Access Compliance Report

Public Rights-of-Way

(Curb Ramps)

Intersection ID: 26462	Main Street: RHETT_BUTLER_PL	Cross Street: TARLETON_TWINS_TR	Location: SE
ADA ID: 17F09EAB6E8B	Ramp Type: Perp	Initial Pass/Fail: Fail	Overall Compliance: No
Codes/Mitigation Info/Possible Solution			Severity Score: 35
			Field Measurements/Component Compliance

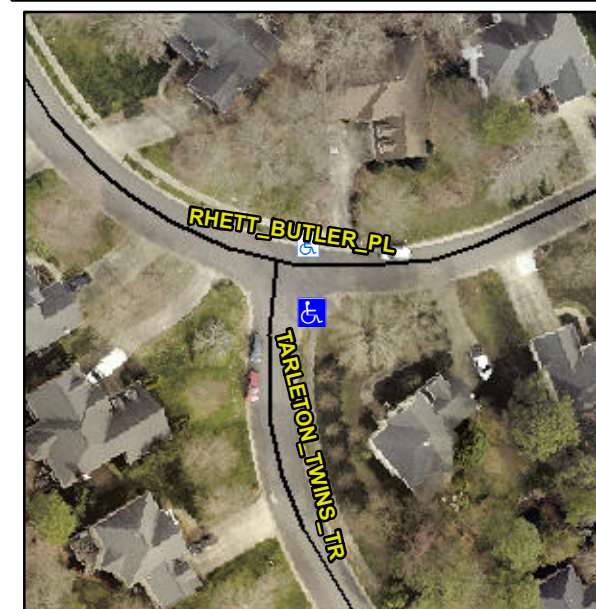
Not Found, R304.5.1

Compliance	Description	Data	Compliance	Description	Data
N/A	Ramp Length (in)	96.0	Yes	Ramp Slope (%)	6.3
No	Ramp Width (in)	25.0	Yes	Ramp XSlope (%)	0.2
N/A	Flare Type LT	N/A	N/A	Flare Type RT	N/A
N/A	Flare Slope LT (%)	N/A	N/A	Flare Slope RT (%)	N/A
N/A	Flare Traversable LT?	N/A	N/A	Flare Traversable RT?	N/A
N/A	Landing Length (in)	N/A	N/A	DWS Provided?	N/A
N/A	Landing Width (in)	N/A	N/A	DWS Contrast?	N/A
N/A	Landing Slope (%)	N/A	N/A	DWS Length (in)	N/A
N/A	Landing X Slope (%)	N/A	N/A	DWS Full Width?	N/A
N/A	Landing Curb? (Y/N)	N/A	N/A	DWS Offset (in)	N/A
N/A	Shared Landing?	N/A			
N/A	Gutter Ponding?	N/A	N/A	Gutter Slope (%)	N/A
N/A	Gutter Lip Ht (in)	N/A	N/A	Gutter X Slope (%)	N/A
N/A	Painted X Walk1?	No	N/A	Painted X Walk2?	N/A
	X Walk 1 Direction	To N		X Walk 2 Direction	N/A
N/A	X Walk 1 Width (in)	N/A	N/A	X Walk 2 Width (in)	N/A
	X Walk 1 Slope (%)	2.4		X Walk 2 Slope (%)	N/A
	X Walk 1 X Slope (%)	0.7		X Walk 2 X Slope (%)	N/A

Remove & Replace Entire Ramp.
